MIDTOWN COMMONS

SUMMARY OF DRB II RECOMMENDATIONS

2301 East Union Street
Project No. 3028872

Design Recommendation III
03/13/2019

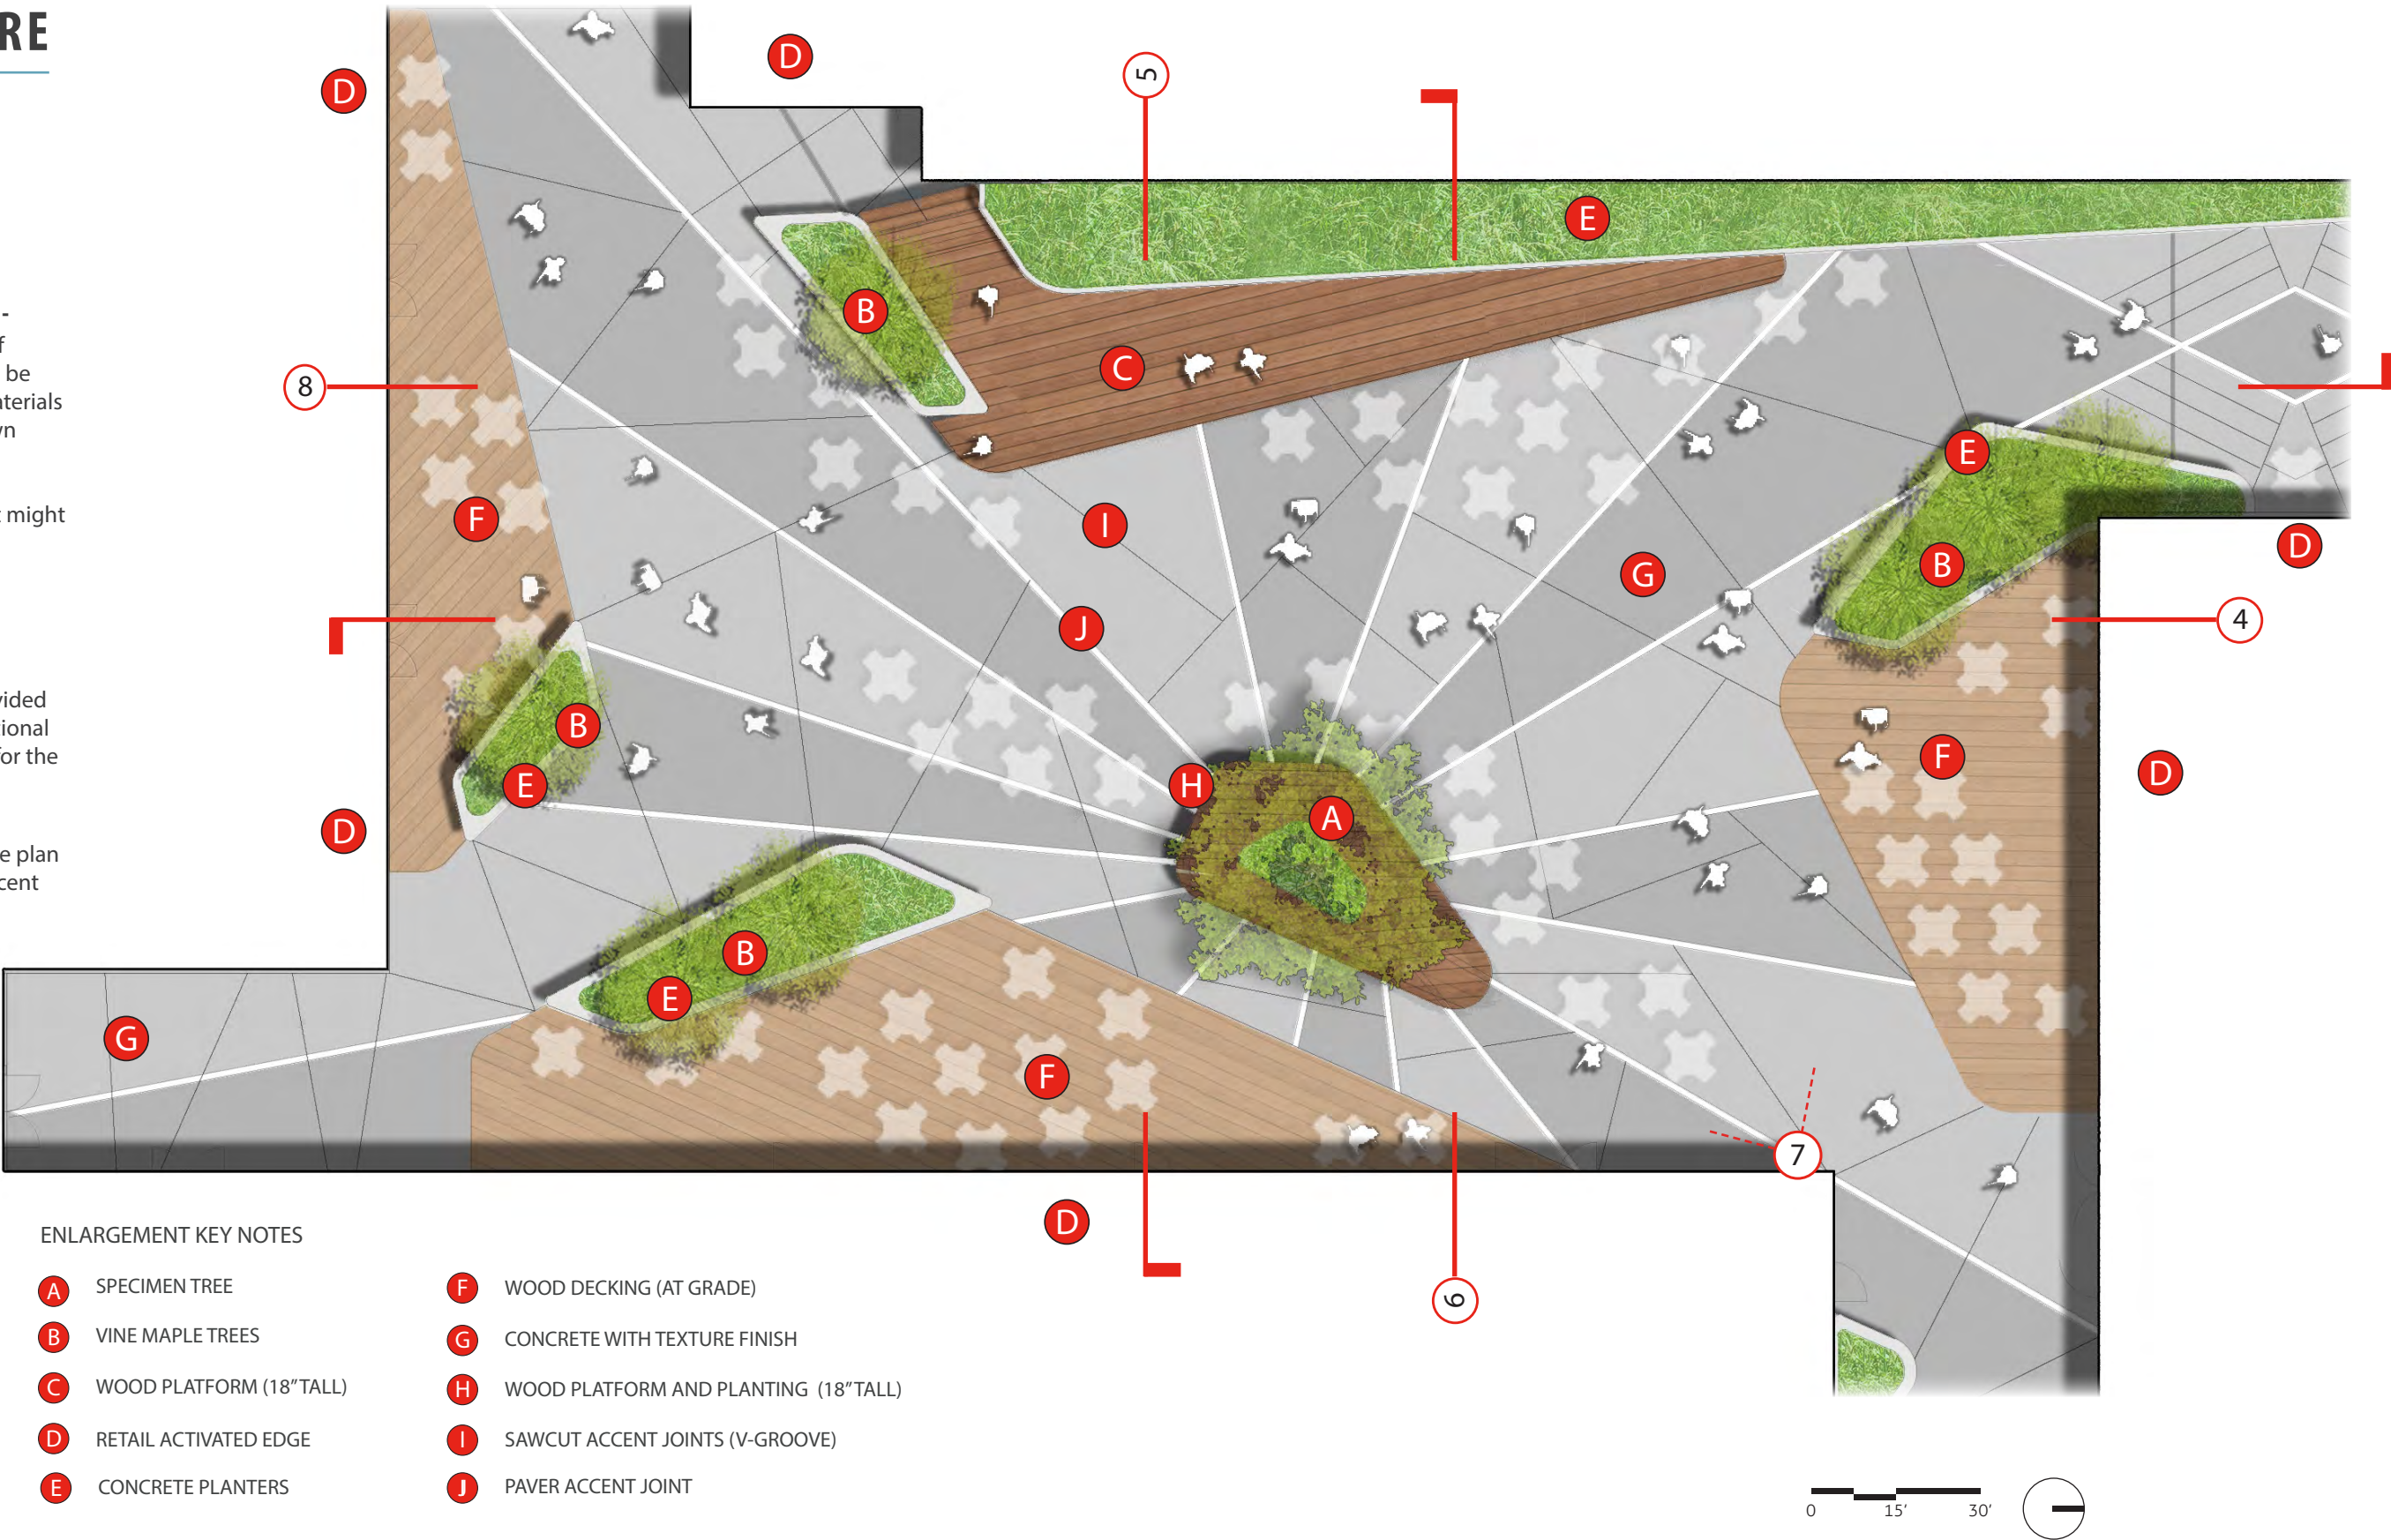
5b GROUND-PLANE MATERIALS-
The Board supported the design of the ground-plane but asked that it be constructed in the high-quality materials with strong-reading patterns shown in the principal documents (rather than lesser materials and minimal construction/expansion joints that might be employed.)

Gound-plane materials have been provided for the Central Square along with additional sections/elevations and a perspective for the Central Courtyard.

Material images have been keyed to the plan and representative images on the adjacent page.

5c CONNECTION TO AFRICATOWN COURTYARD

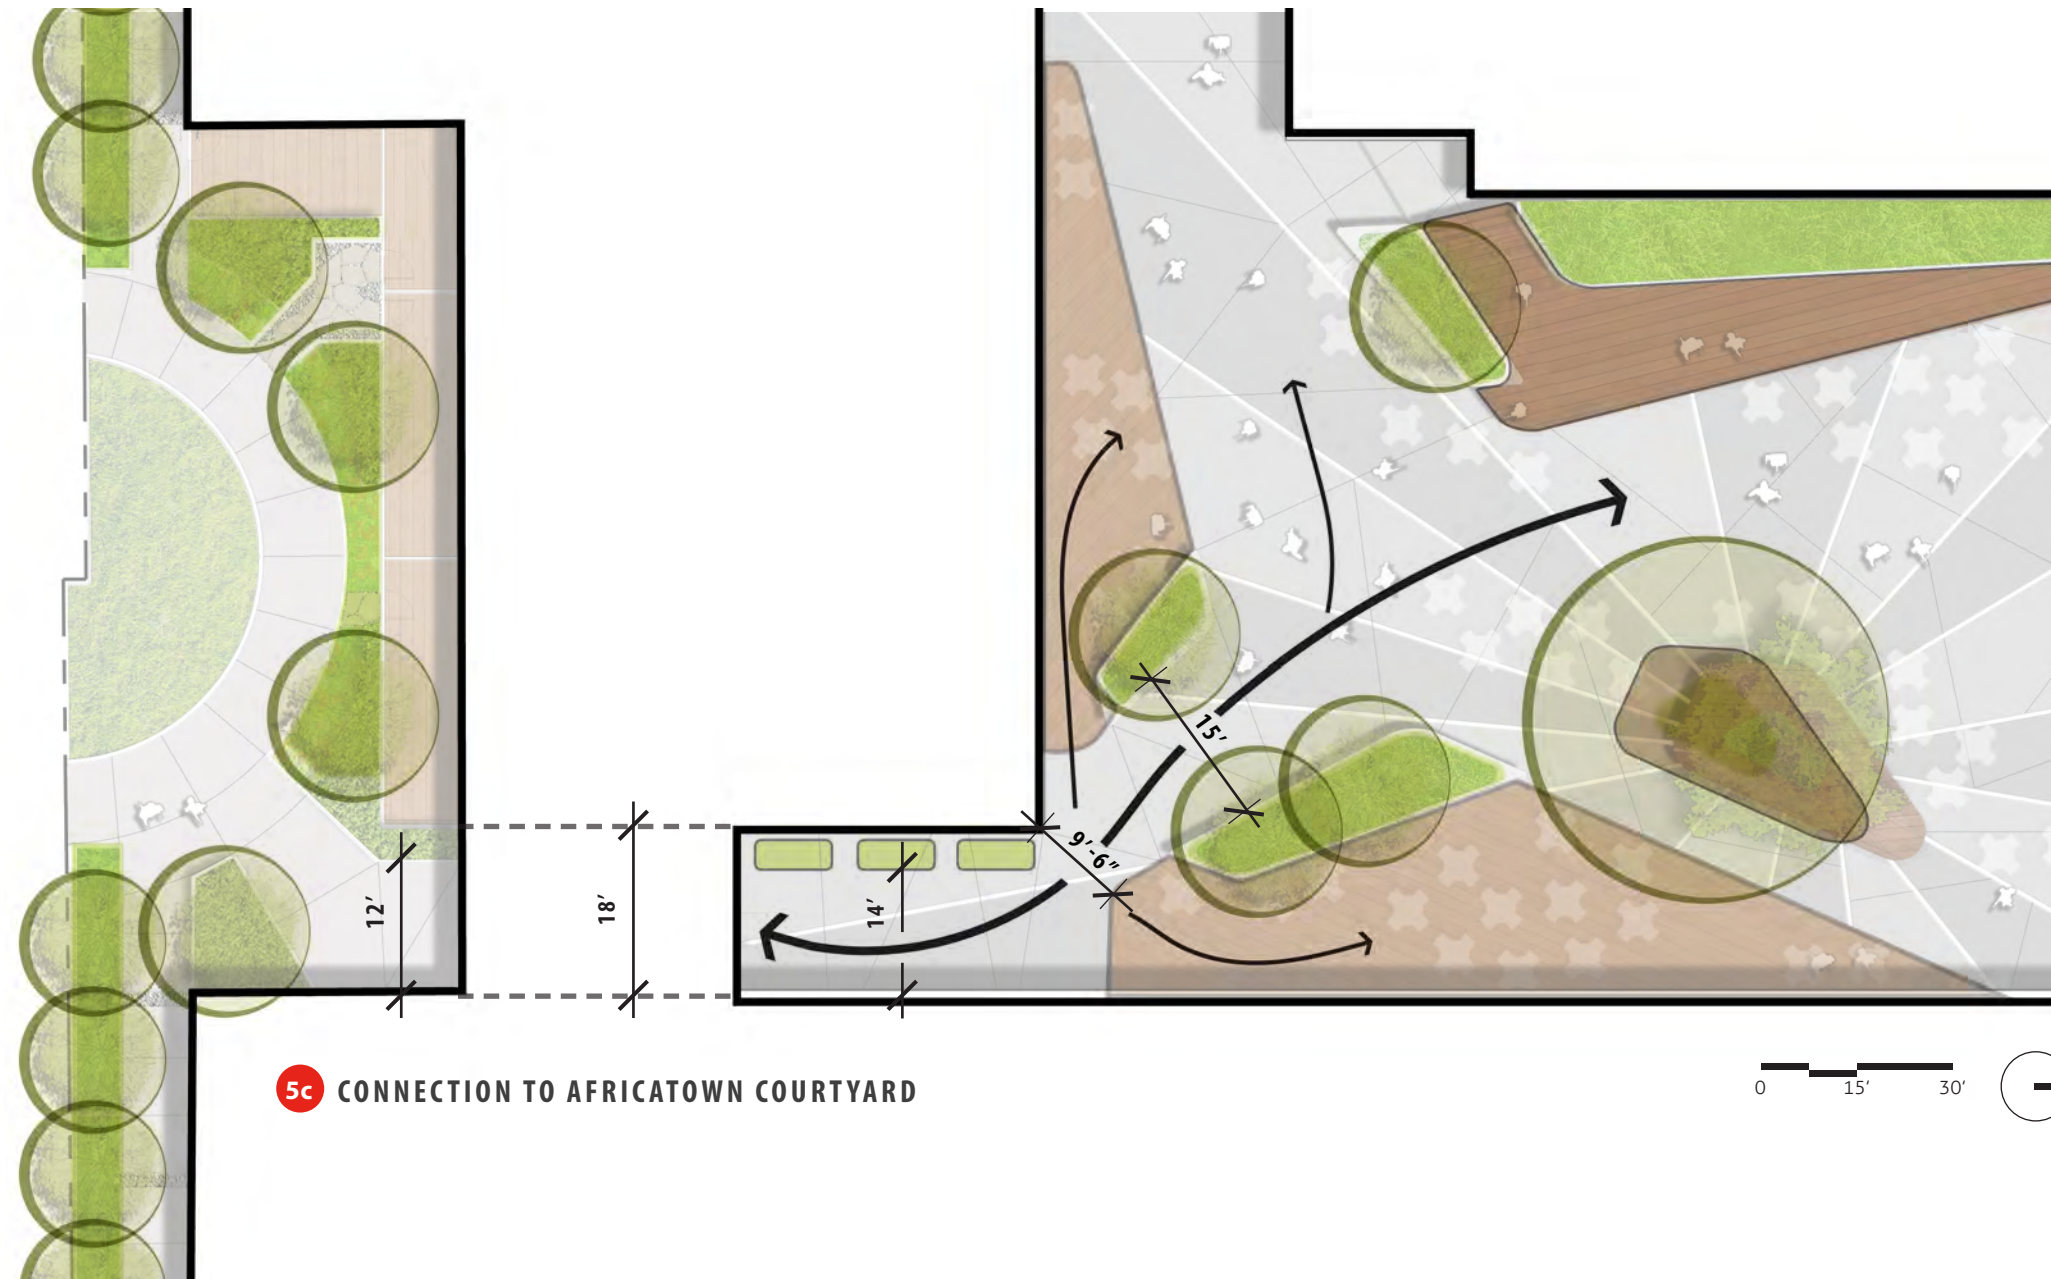
- 5c CONNECTION TO AFRICATOWN COURTYARD-**
The Board supported the connection to the future courtyard created by this project and the proposed Africatown project and asked that it be developed as a more direct connection rather than the 'pork-chop' shape shown in these drawings.

- The residential courtyard (Africatown Courtyard) has been re-designed to accept a direction connection through the building to the Central Square's Southeast corner. The design change removed a residential unit and the adjacent unit's outdoor patio to accommodate this change.
- Courtyard planters were moved away from the building in the SE Corner of the Central Square to allow for visual and physical connections.

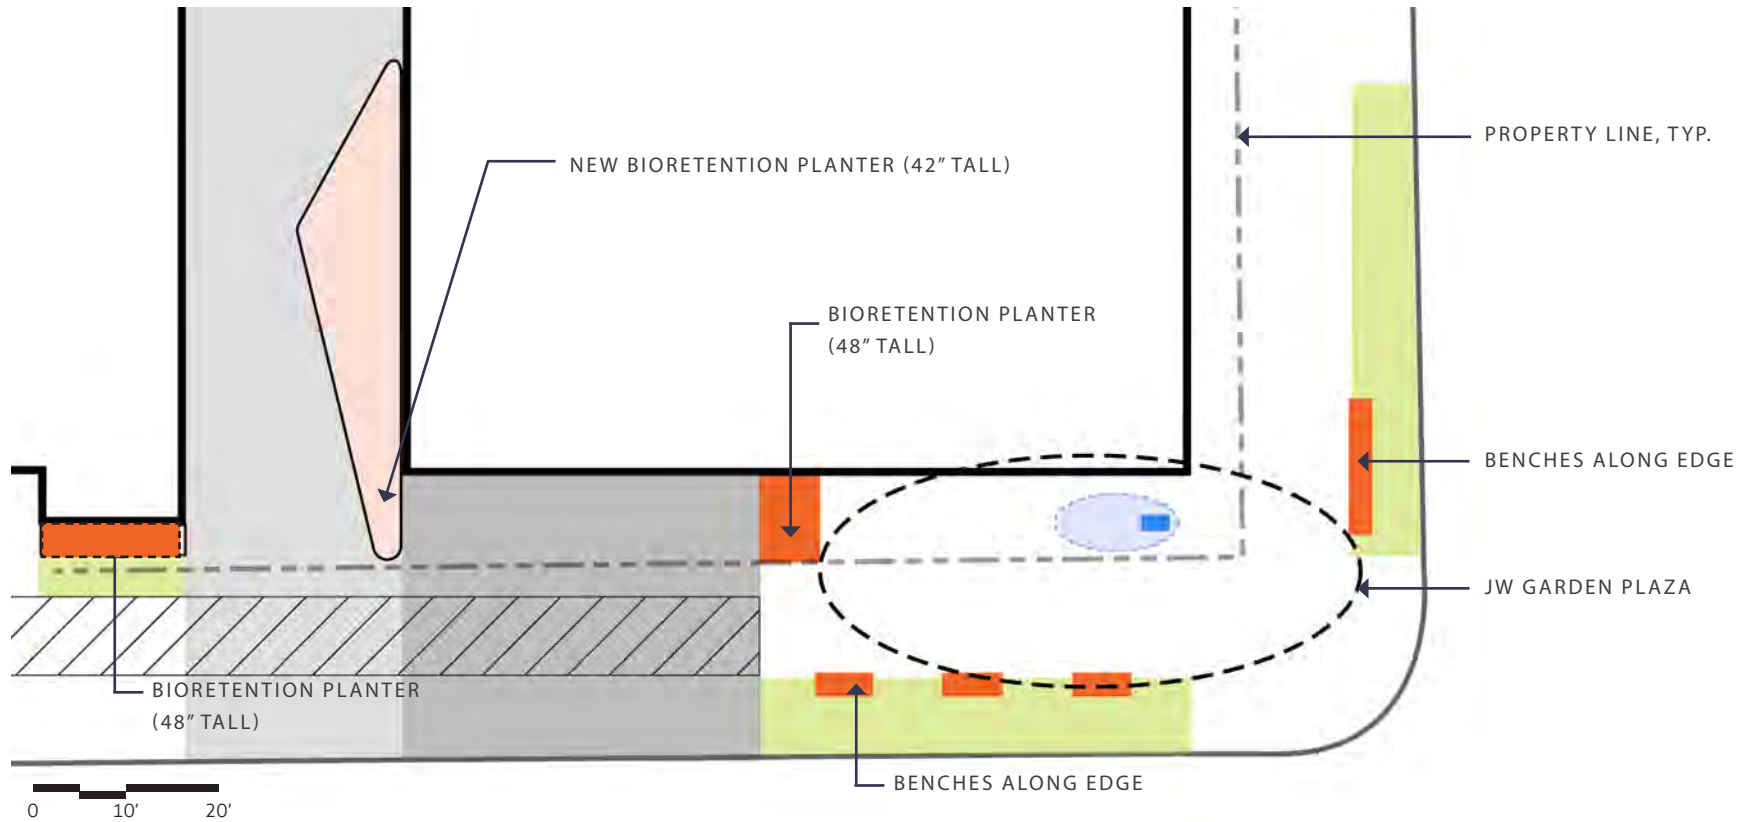
6a LOCATION DESIGN DEVELOPMENT- The Board discussed the location and details of this installation at length, concluding that the current location at 24th and Union could work but needed further design development to insure a successful installation.

- Further design development of the original location and approved concept (by the Cultural Center) is provided showing a memorial garden and plaza extending the length of the streetscape on 24th Avenue. The theme of the fountain and storm-water collection along 24th Avenue parallels the original fountain intent depicting the native Salmon's struggle for life with African-American's struggles in society and history in America.

- This design connects the neighborhood through the site to the Liberty Bank Plaza at the corner of 24th and East Union Street.
- Diagrams have been developed to show the ground level and tree canopy level enclosure of the open space at the corner of 24th and East Union Street.

- The updated design also consider pedestrian safety along 24th Avenue, providing a clear and delineated mixing zone for pedestrians and accent paving for vehicular paving, warning the pedestrian of a change in use. Raised planters now flank the entry to the garage and loading area to prevent pedestrians from unknowingly moving into that conflict area at the top of the parking ramp.

5a STUDY 3: SIGNATURE TREE SHIFTING SOUTH

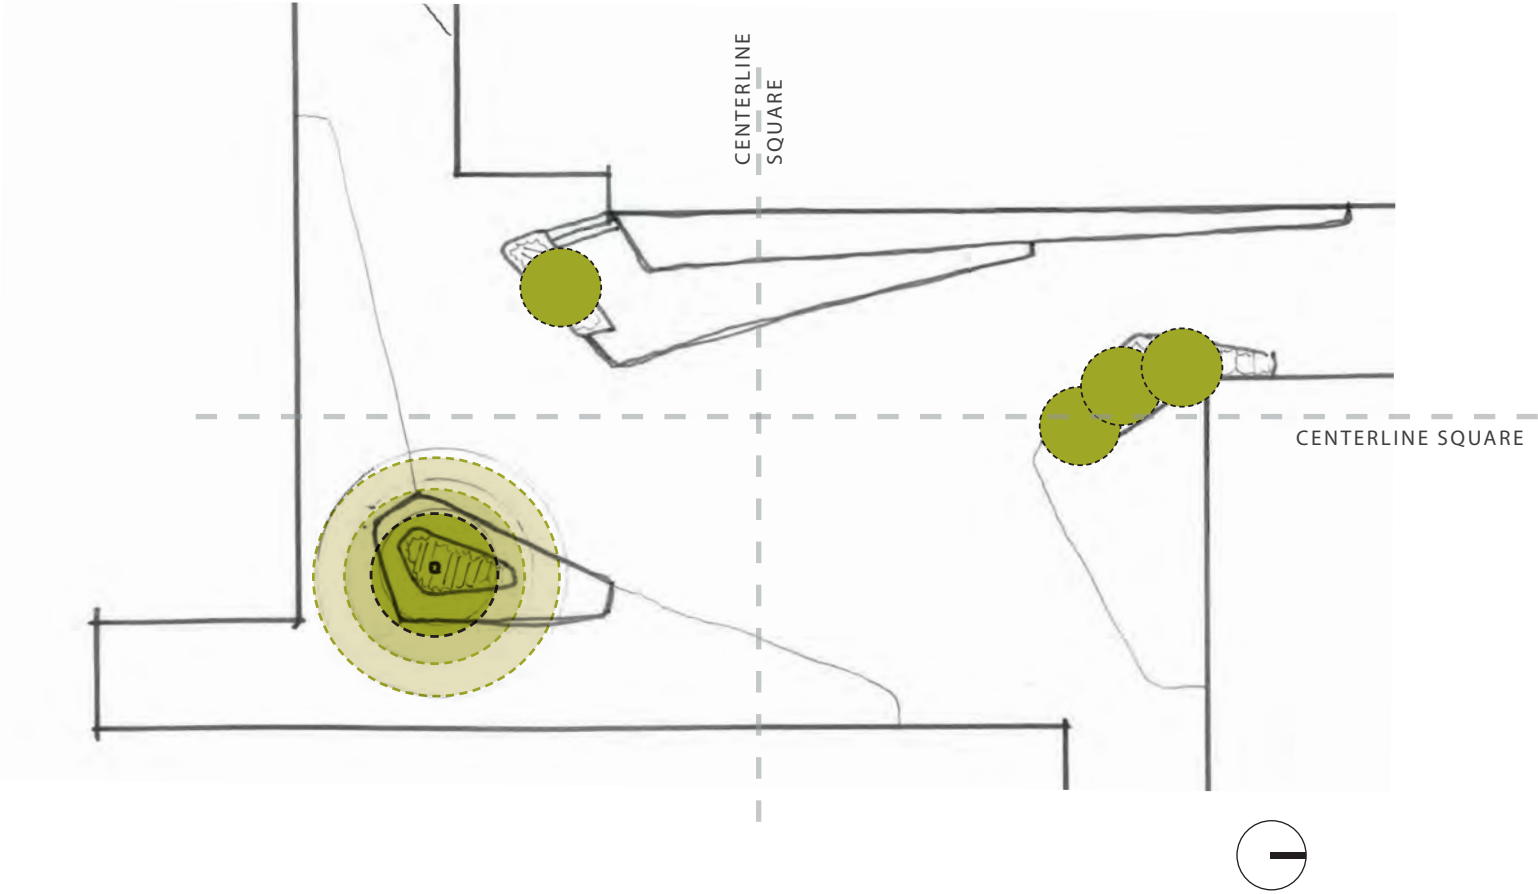
- **TREE LOCATION-** After a wide-ranging discussion of the location and “role” of the proposed tree, a majority of the Board supported the relocation of the tree away from the center of the courtyard with the following notes:
 - i. Egress to and from retail storefronts not to be compromised
 - ii. The accommodation of a wide range of users and uses be carefully considered.

- TREE FOCAL POINT FOR 23RD AVE PORTAL
- PROVIDES MORE FLEXIBLE SPACE FOR MAJOR EVENTS
- SMALLER EVENTS WILL SEEM OUT OF SCALE IN LARGE OPEN SPACE
- RELOCATES STRUCTURAL PIT AGAINST RETAIL EDGE
- CROWDS SOUTH AND EAST BUILDING FACADES AND RETAIL EDGE
- REMOVES PUBLIC FOCUSED ‘CENTRAL ROOM’ FOR DAILY USERS
- REMOVES PLANTINGS AND SMALL ACCENT TREES FROM SQUARE
- CHANGES TREE TO FULL SHADE - SLOWER GROWTH, DIFFERENT SPECIES TBD
- CREATES “HIDDEN” ZONE AT ENTRY TO RESIDENTIAL COURTYARD (CPTED)
